SUBMIT IN TRIPLICAT	7. If Unit or CA/Agreement, Name and/or No Lindrith Unit				
Type of Well     Oil Well	8. Well Name and No.  Lindrith Unit 48				
3a. Address  2010 Afton Place, Farmington, NM 8 4. Location of Well (Footage, Sec., T., R., M., or Survey 1 800' FSL, 1550' FEL, Sec. 10, T24	9. API Well No. 30-039-05519 10. Field and Pool, or Exploratory Ar E. Blanco Pictured Cliffs 11. County or Parish, State				
12. CHECK APPROPRIATI	E BOX(ES) TO IN	DICATE NATURE OF 1	NOTICE, REPO	Rio Arriba NM ORT, OR OTHER DATA	
TYPE OF SUBMISSION TYPE OF ACTION					
Notice of Intent  Subsequent Report  Final Abandonment Notice	Acidize Alter Casing Casing Repair Change Plans Convert to Inject	Deepen Fracture Treat New Construction X Plug and Abandon Plug Back	Reclamati	ete Other

Energen Resources intends to permanently Plug and Abondon the Lindrith Unit 48 according to the attached downhole and reclaimation procedures.

#### PLUG AND ABANDONMENT PROCEDURE

#### **Lindrith Unit #48**

## Proposed P&A

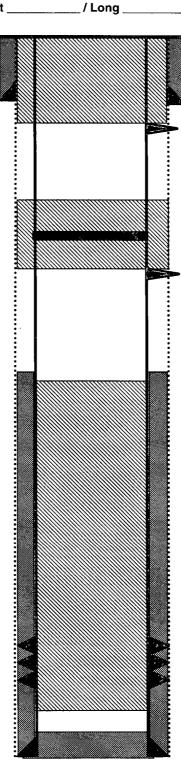
See COA

- 1. Plugging operations authorized are subject to the attached "General Requirements for Permanent Abandonment of Wells on Federal and Indian Lease."
- 2. Farmington Office is to be notified at least 24 hours before the plugging operations commence (505) 564-7750.
- 3. The following modifications to your plugging program are to be made:
  - a) Bring the top of plug #1 to 2618 ft. to cover the Ojo Alamo top. Adjust cement volume accordingly.
  - b) Bring the top of plug #2 to 1224 ft. to inside/outside cover the Nacimiento top. Adjust cement volume accordingly.

Operator must run a CBL from 3203 ft., or as deep as possible, to verify cement top. Outside plugs may be revised, based on CBL result. Submit electronic copy of the log for verification to the following BLM address: tsalyers@blm.gov
